DATE: March 13, 2010
TO: Michael J. Gillis, Virginia Correctional Enterprises Document Management Services
FROM: Jo Anna Ripley, Stormwater
PO: 270712
RE: Files Approved for Scanning

Project Name: KINGDOM HALL OF JEHOVAH'S WITNESSES
Structure/BMP Name: PC 110
Project Location: 5493 MOORETOWN RD
BMP Location: REAR OF SITE
County Plan No.: SP - 104 - 99

RECORD DRAWING
DETENTION BASIN / BMP
KINGDOM HALL
OF
JEHOVAH'S WITNESSES
5493 MOORETOWN ROAD
JAMES CITY COUNTY, VIRGINIA
SCALE: 1"=20' DATE: 12/11/00

SITE PLAN FOR KINGDOM HALL OF JEHOVAH'S WITNESSES JAMES CITY COUNTY, VIRGINIA

C-3
3 OF 8

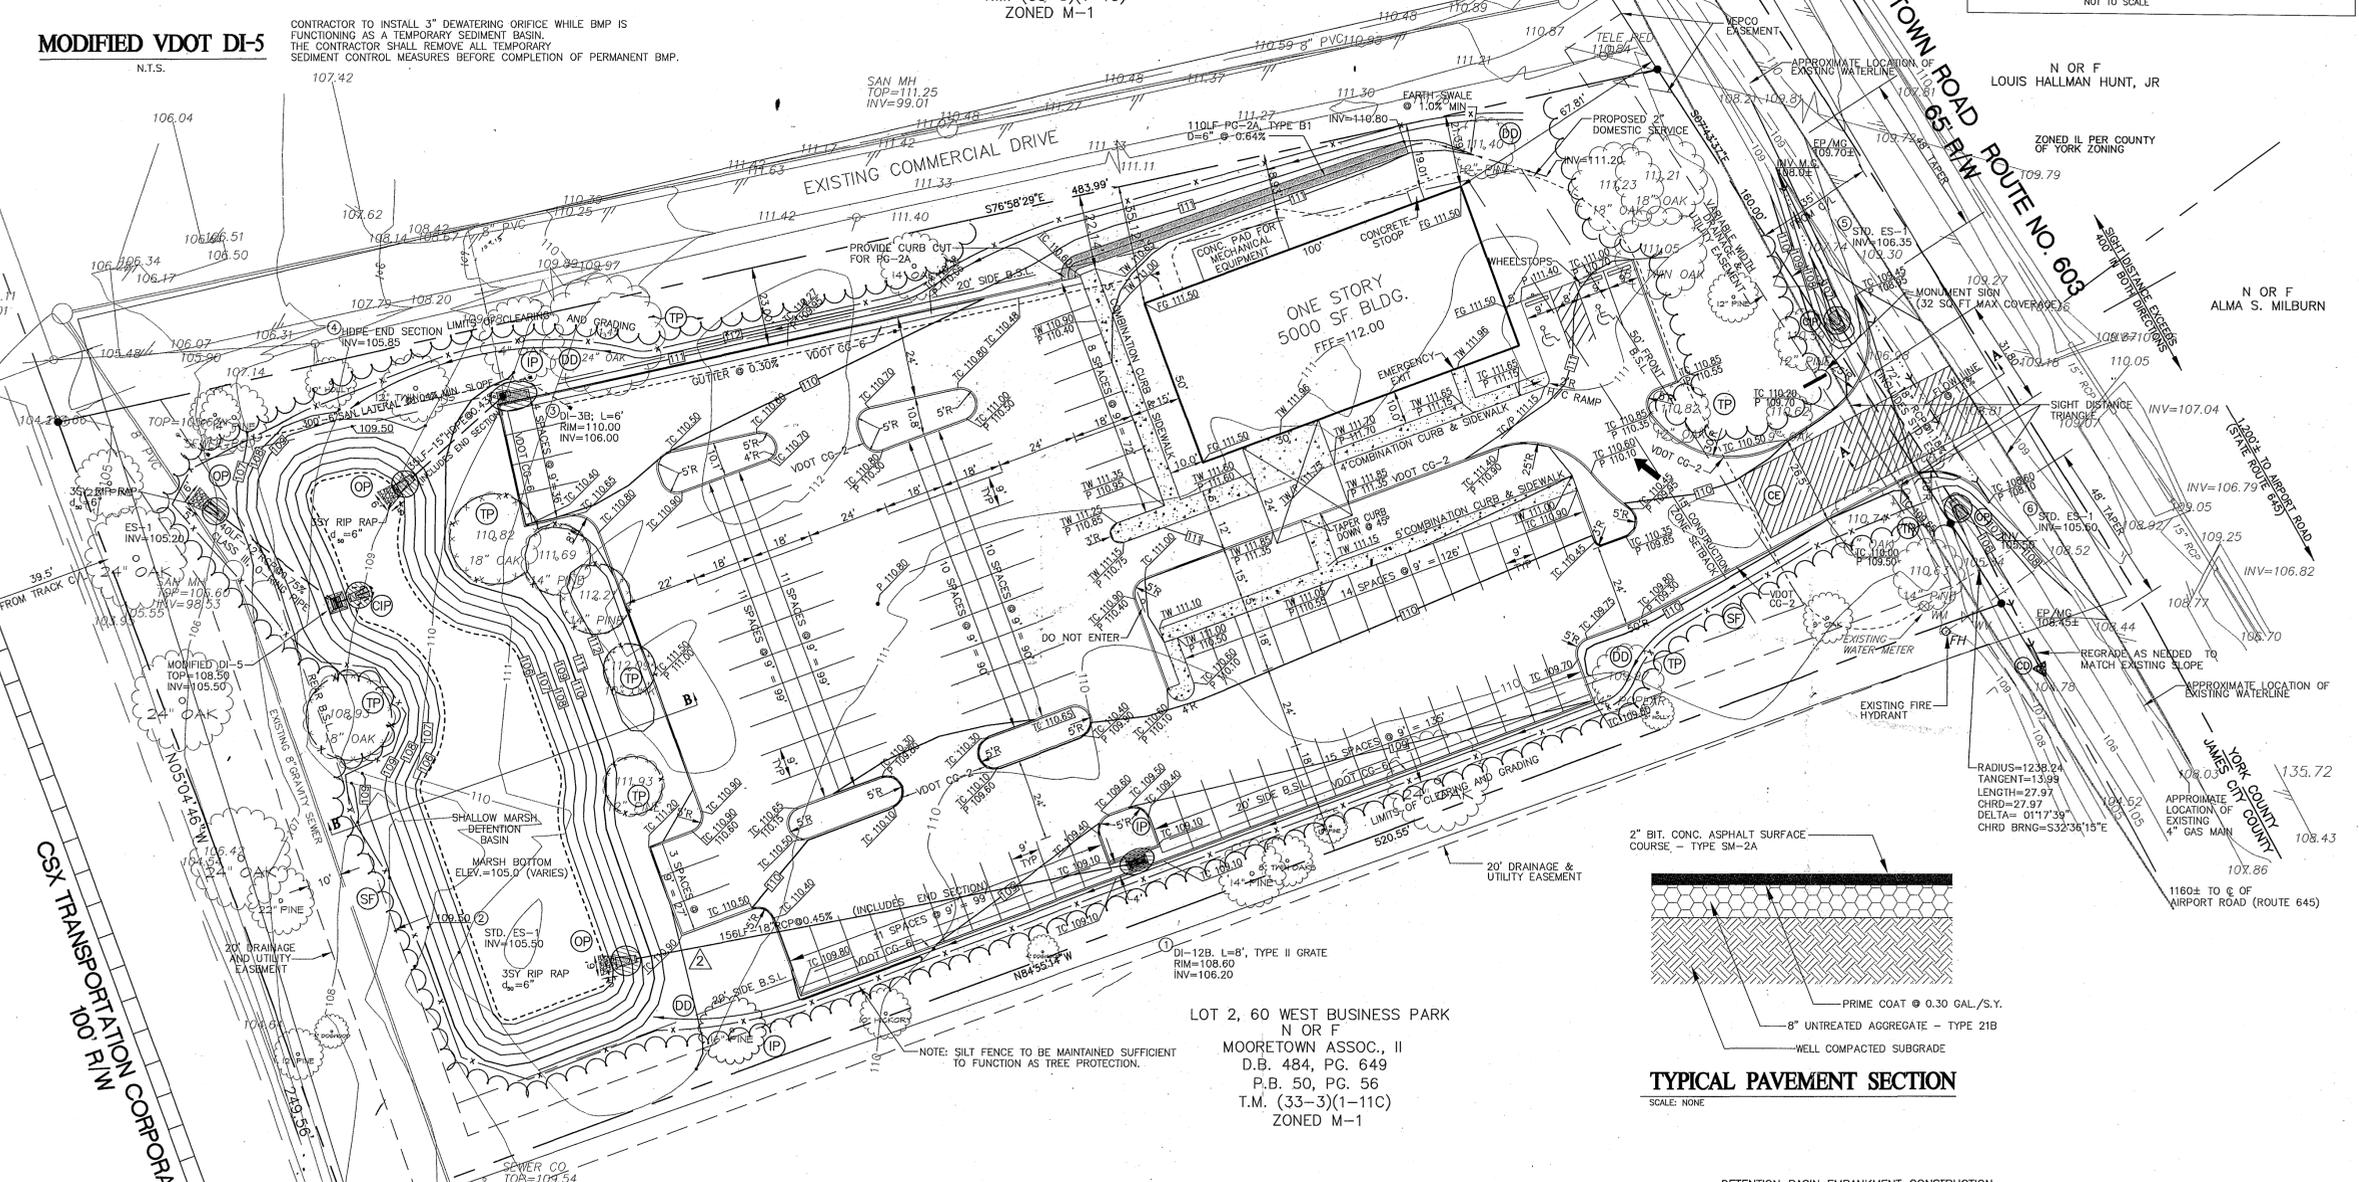
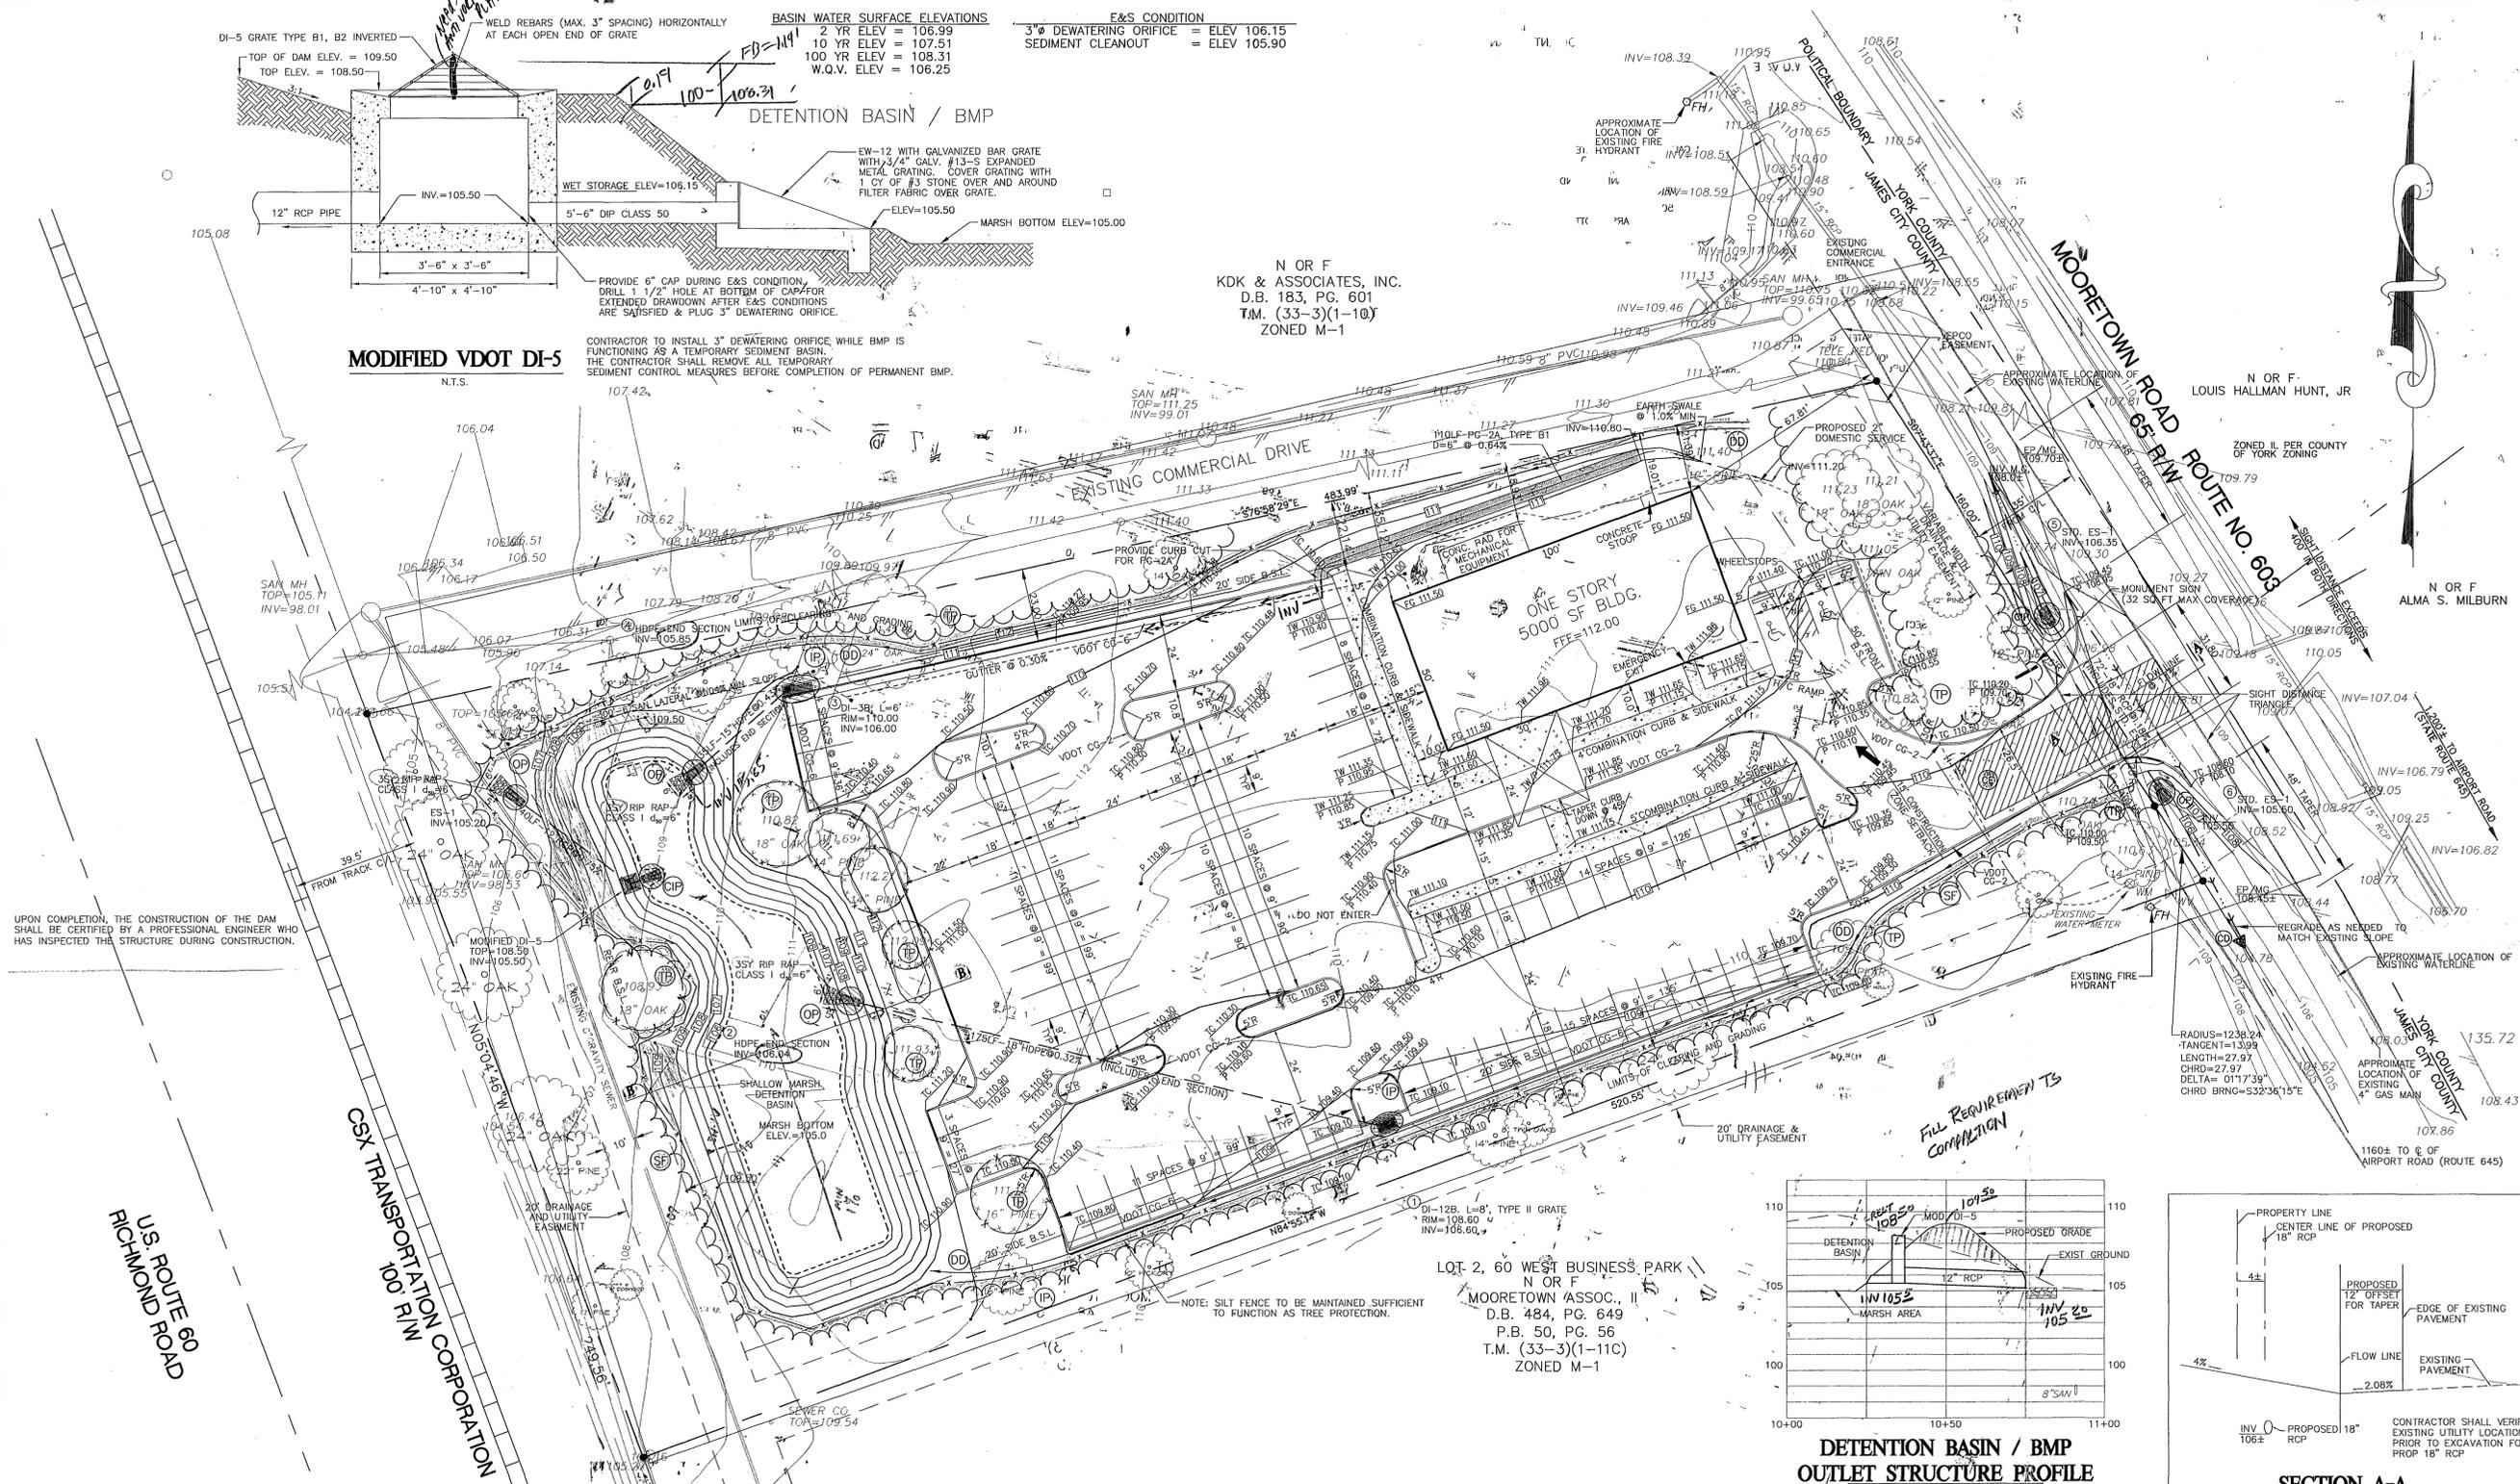
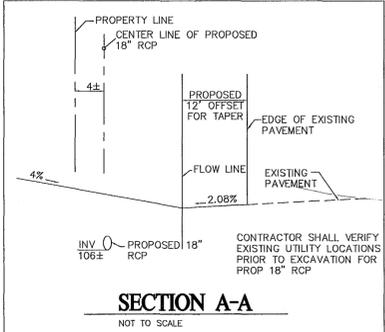
29. The riprap pad shown at the outlet end of the 4 inch drain from the pond is shown slightly offsite on Sheets C-2 and C-3. Please correct.
30. No stormwater management/BMP maintenance plan was provided.

- m ✓ 20. Section A-A for the "southern channel" on Sheet C-3 shows 2H:1V sideslopes. Sideslopes of 3H:1V or steeper requires use of erosion control blanket. Show the erosion control blanket on the typical section.

- ✓ 1. A Land Disturbing Permit requirement is acknowledged.
- ✓ 2. An Inspection/Maintenance Agreement requirement is acknowledged.
- ✓ 3. A note has been added to Sheet C-3 concerning the requirement for professional engineer is certification of construction of the dam.

- 28. A profile along the basin outfall has been added to Sheet C-3.
- 29. The basin outlet pipe and structure has been revised.
- 30. A detention basin/BMP maintenance plan has been added to Sheet C-2.
- 31. Water surface elevations for water quality volume, 2yr, 10yr and 100 yr routed elevations added to Sheet C-3.
- 32. The 4" PVC drain and grate have been eliminated.
- 33. The curb cut flumes have been eliminated.
- 34. All proposed storm drainage pipe and structures have been properly labeled.
- 35. All proposed storm drainage pipe and structures have been properly labeled.
- 36. The drainage ridge for the culvert has been added to Sheet C-2 ~~Sheet C-3~~.
- 37. The culvert has been redesigned with a tailwater elevation equal to the depth of flow in the receiving road ditch. The computed headwater elevation is 1.62' below the edge of pavement.
